Recall Campaign Bulletin

Campaign No. 2019080010, September 2019

SUBJECT: Model GLA-Class vehicles (156 platform)

Check rear middle seat belt, correct if necessary

Figure 2

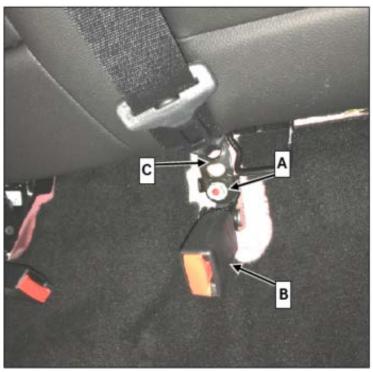
- 1. Remove rear seat cushion.
 - i For basic data, see AR91.12-P-1020NKC.
- 2. Remove threaded connection (A, Figure 2) of seat belt buckle (B, Figure 2) for left rear seat belt and seat belt end fitting for center rear seat belt.
- 3. Screw seat belt end fitting (C, Figure 2) for center rear seat belt to left seat belt buckle.

Torque 35 Nm.

i Order: Seat belt buckle, seat belt end fitting, nut.
